Landmark Commission City Building

LANDMARK COMMISSION
REPORT

APPLICATION FOR EXTERIOR
RENOVATIONS TO
403 E. ADAMS STREET

Reference Number: LC-03-18

PROPOSED SIX FOOT IRON FENCE PLACEMENT
PROPOSED BRICK UNLOADING AREA IN BOULEVARD

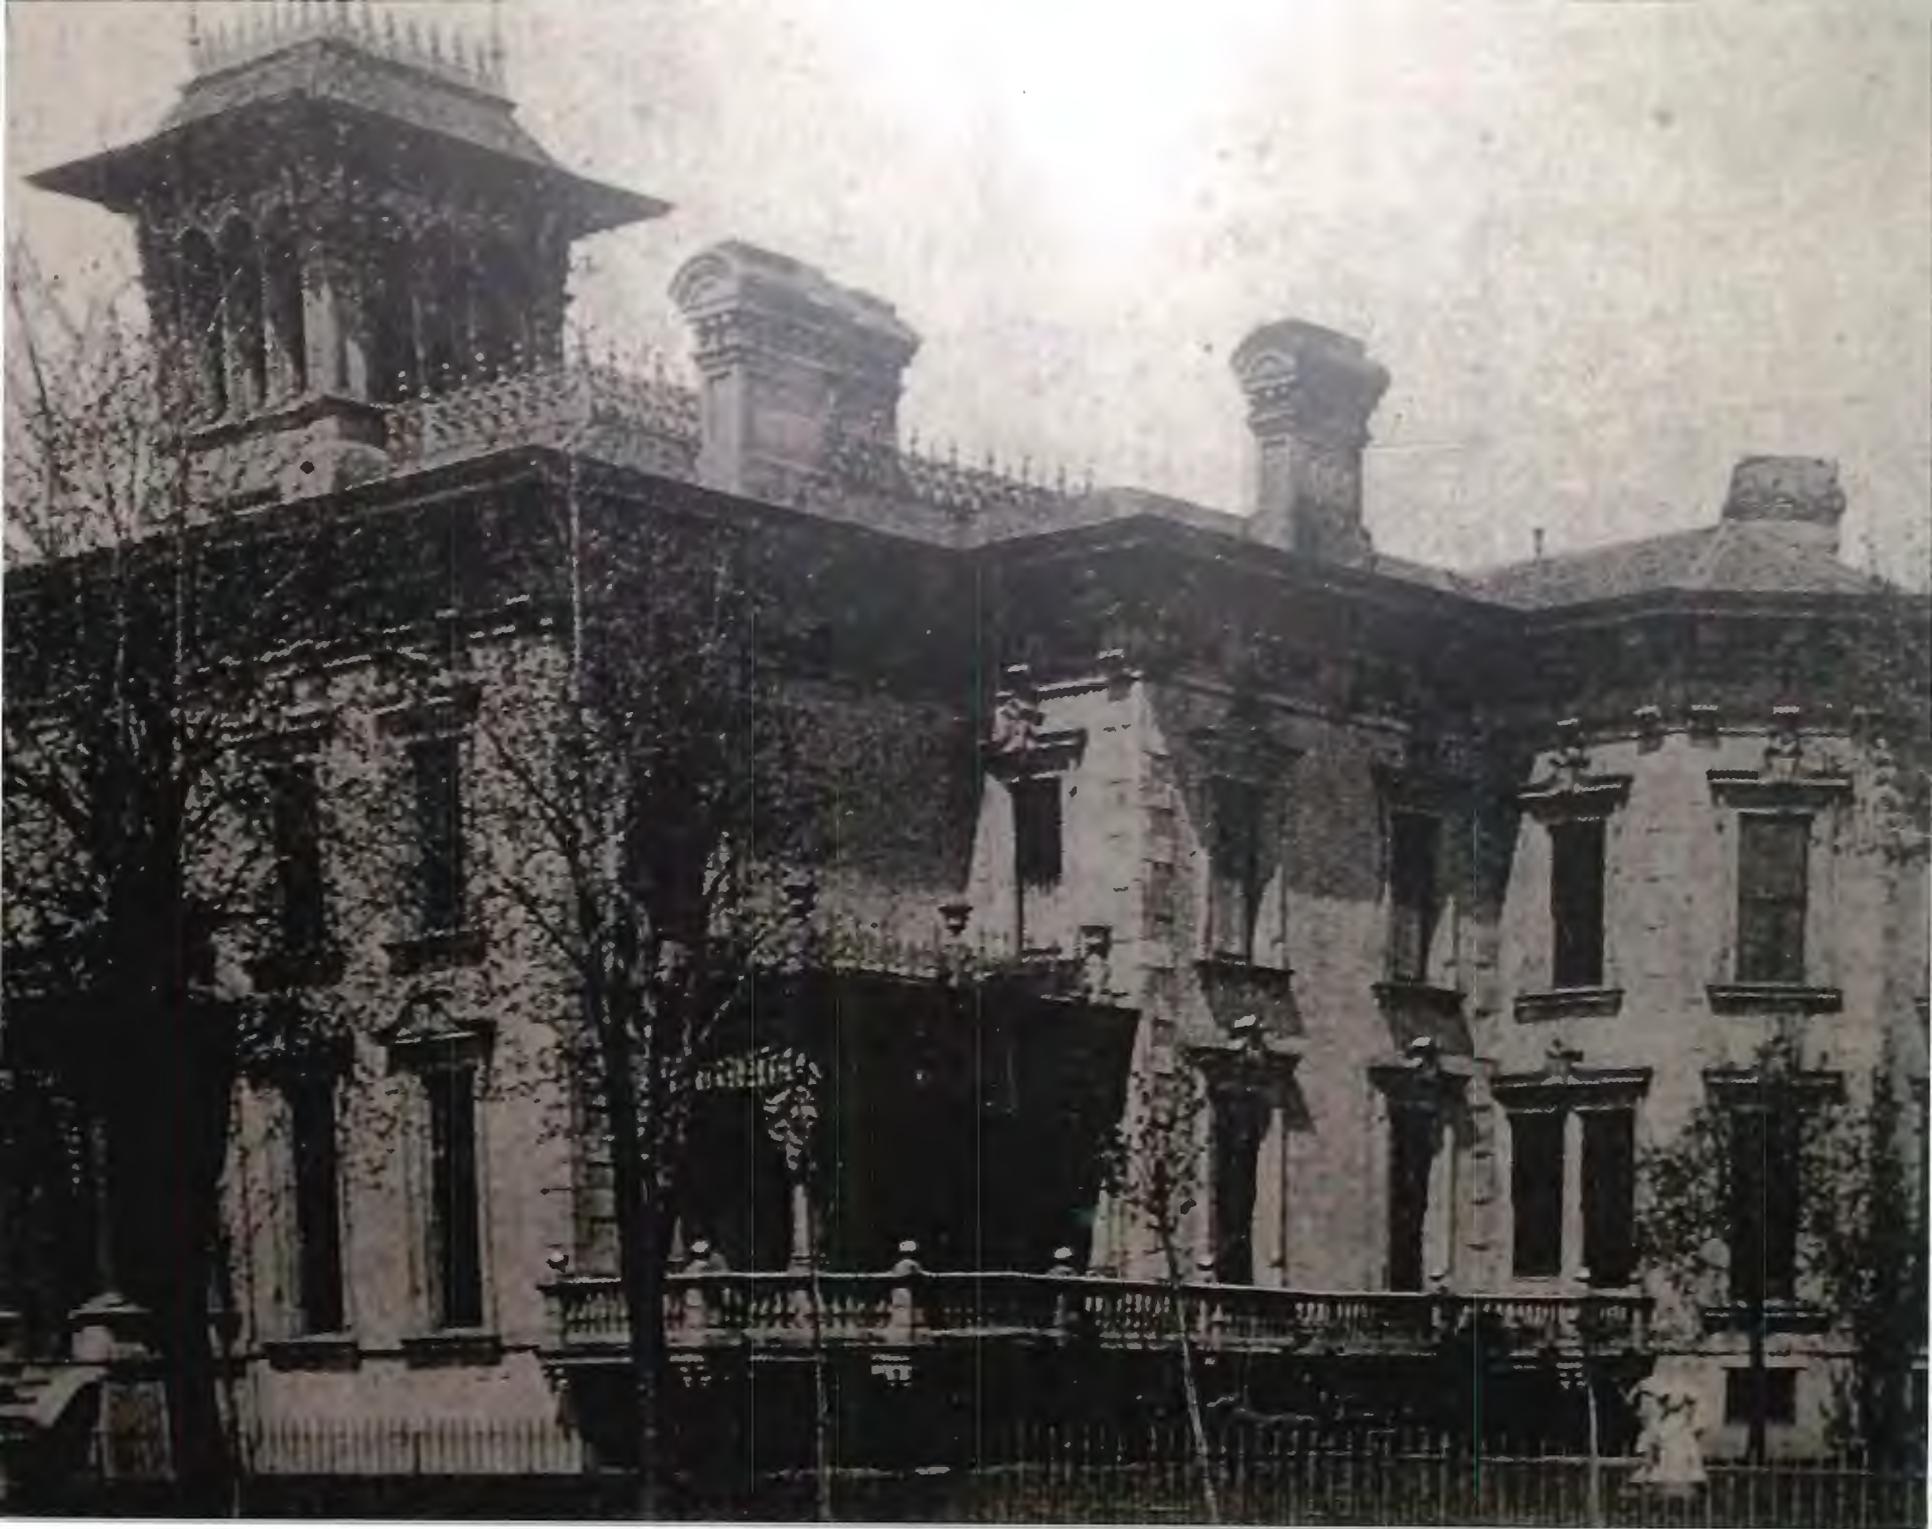
The applicant has provided a sketch of a 6' fence with openings that will contain a decorative feature. Staff has requested information from the applicant regarding what type of material the fence will be and a site plan indicating the proposed location. Staff will need to assure that the fence meets the zoning requirements in regards to height and location. The Design Guidelines state that traditional forms such as picket fence, plain board fences, and iron fencing in historic district are appropriate. Inappropriate styles would include chain link, stockade, shadow board, and other contemporary designs.

The applicant has provided a sketch of the proposed location of the fence, the proposed six foot iron fence is to surround the property. The applicant will need to apply for a variance to allow a 6' fence within the side yard.

Planning Staff believes that that the applicant has provided the majority of the requested information. However, staff needs pictures of each elevation noting what is proposed for each window. The applicant has proposed a deck/ veranda with a design which is consistent with that of the time frame the home was constructed. The proposed iron fence is an appropriate material, as the design regulations stated that fence shall be of a traditional material.

PROPOSED RECONSTRUCTION
 OF EAST PORCH and
 SURROUNDING VERANDA
 CONCRETE COLUMNS & BEAMS
 CONCRETE DECK

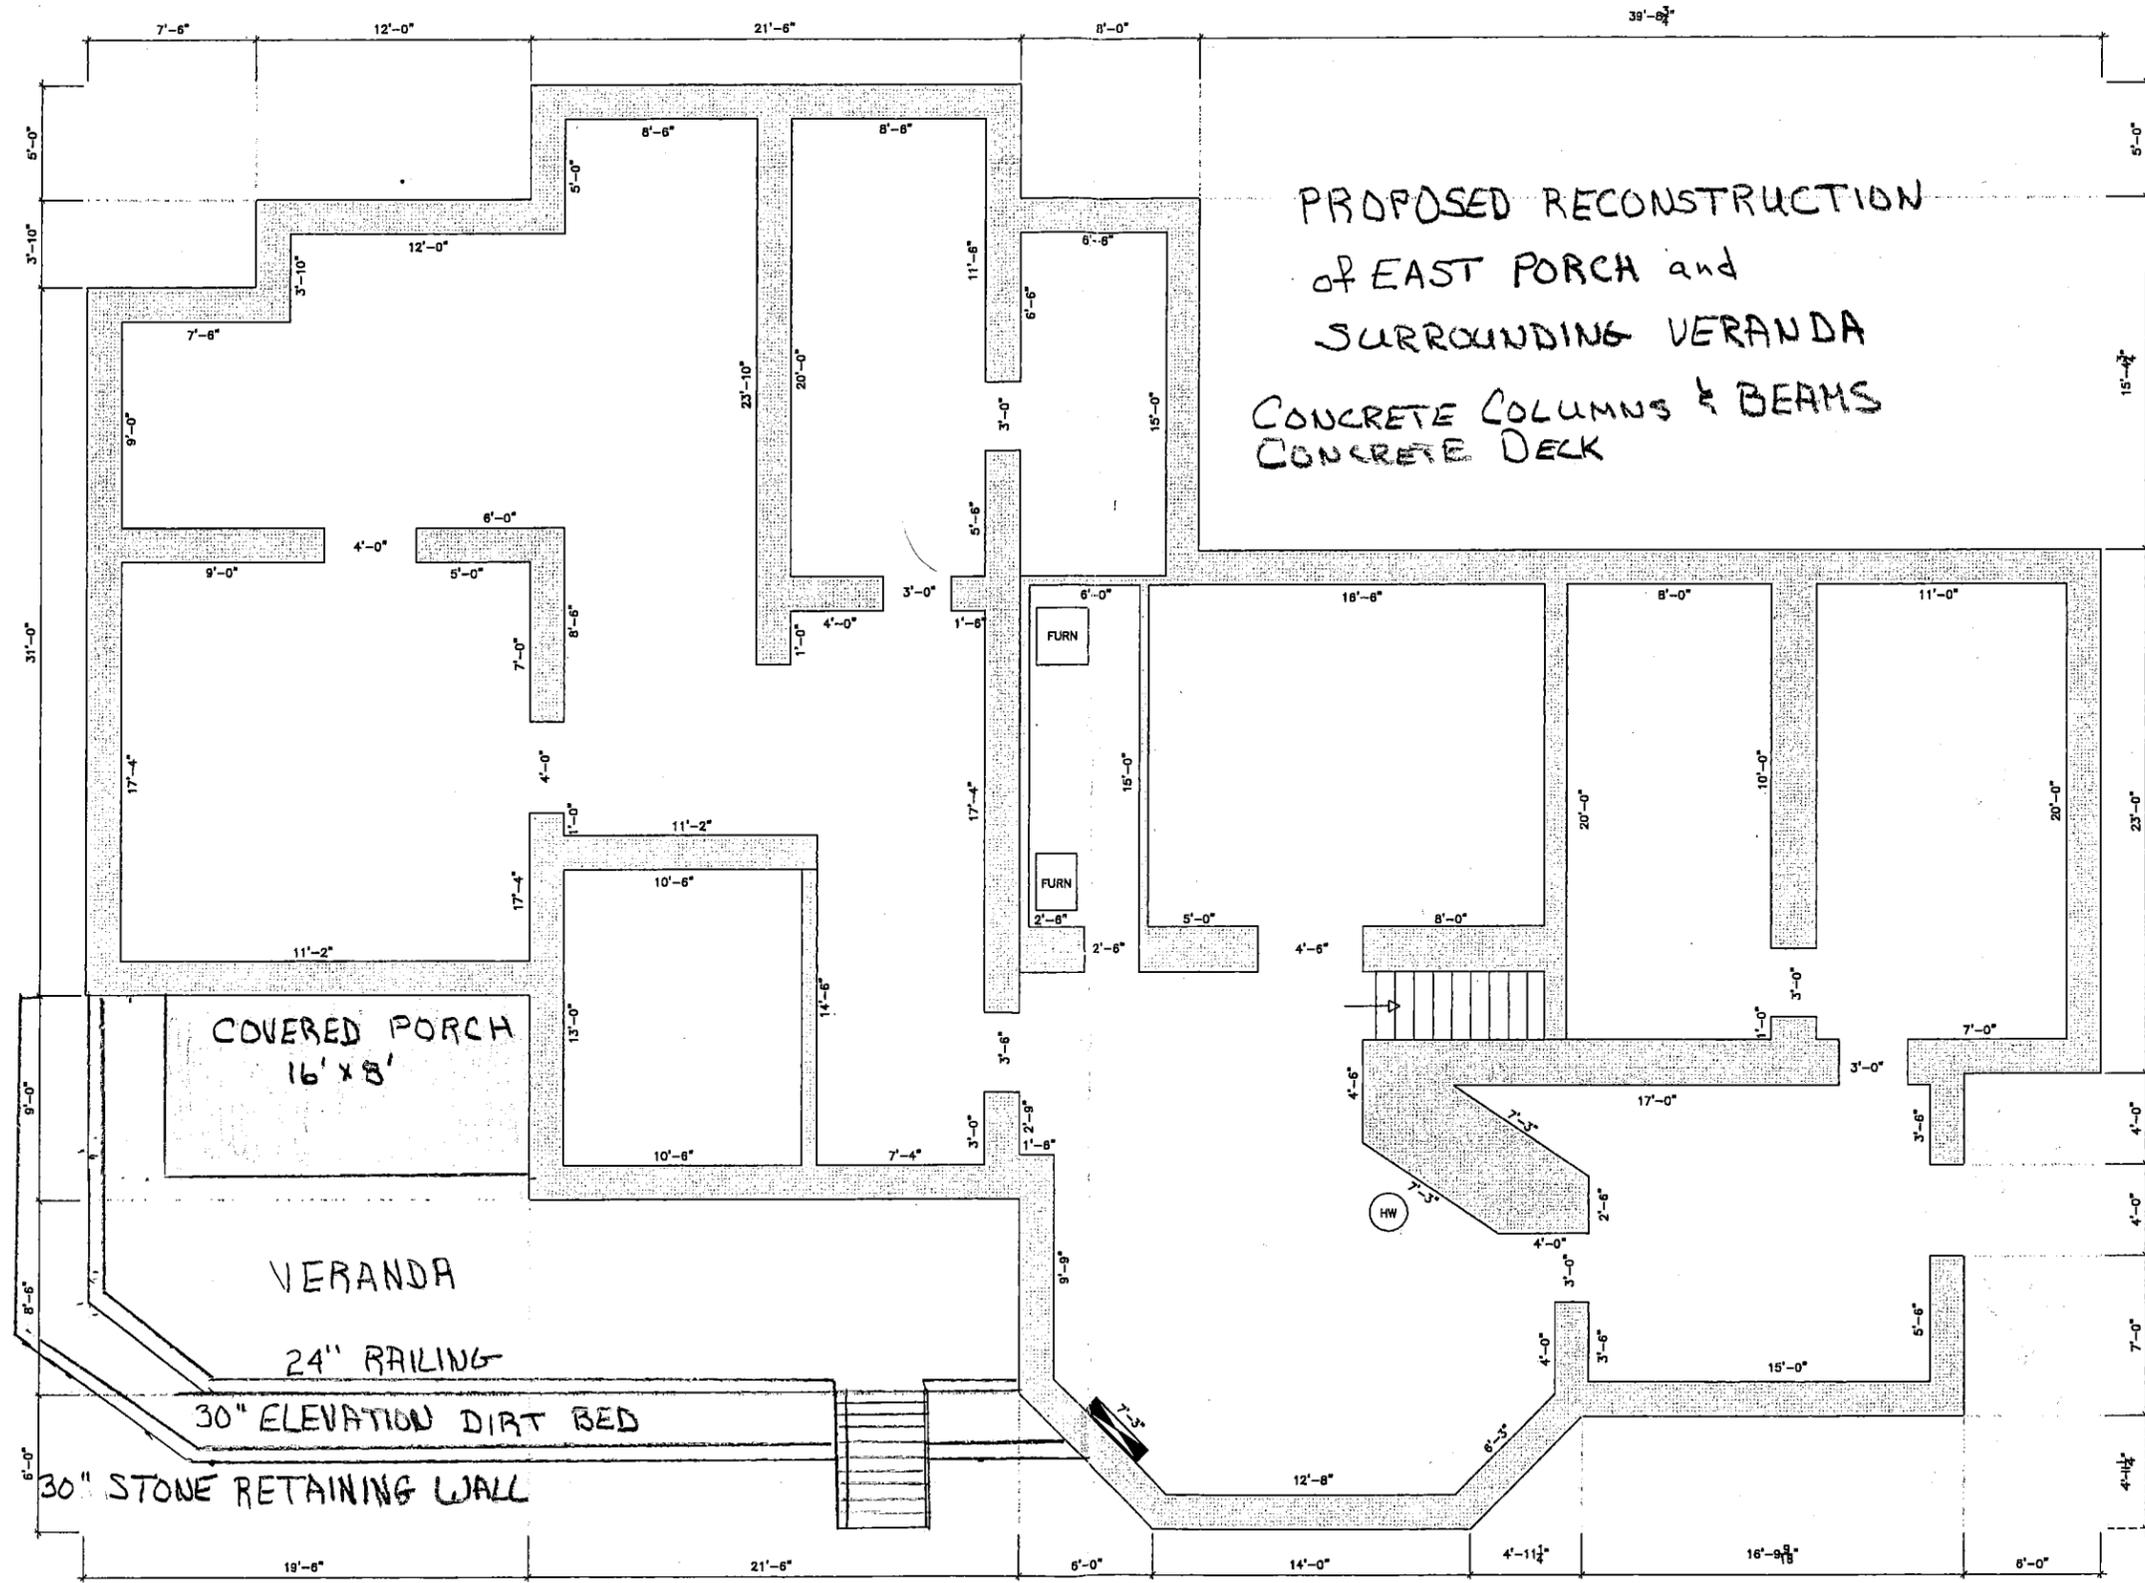
The applicant has provided sketches for the proposed deck and entrance feature. The applicant is proposing to install a railing and concrete stairs along the porch entrance, and a deck within the rear of the building. Per the application the proposed east porch and terrace will be a reconstruction of the original. The applicant has stated that they will be utilizing reproductions of the original posts, the entire porch floor will be precast concrete on columns and beams. The Design Guidelines state that the porches should be very simple in design and detail and should be preserved to their original historic form.

The applicant is also proposing a deck within the rear yard, the plans call for a composite material for the deck. The Secretary Interior Standards state that the material that are being utilized should be replaced with an in kind or constructed with a compatible substitute material with the existing historic structure. The applicant has proposed a railing system to match with the historical images, however the deck is proposed of a composite material. The applicant will need to provide a site plan indicating setbacks for both the entrance feature and the deck, as staff will need to review to assure all setbacks meet zoning requirements.

Planning staff met with the applicant to discuss the comments received by the Landmark Commission and further clarified the materials proposed for the deck/ veranda on Adams Street. The applicant has clarified that the deck/ veranda is proposed to be a concrete deck with concrete columns/ beams and a retaining wall shall be installed surrounding the deck. A proposed sketch of the revised deck is enclosed within the packet, as well as an image of the original veranda.

Staff supports the proposed deck, veranda, fence, and door replacement. Staff understands that the replacement of the windows with the wood will be costly. Staff recommends that all 1st and 2nd floor windows along Adams and Franklin Street be full wood windows, but that the 3rd floor and the interior facing windows be permitted to be wooden with aluminum cladding.
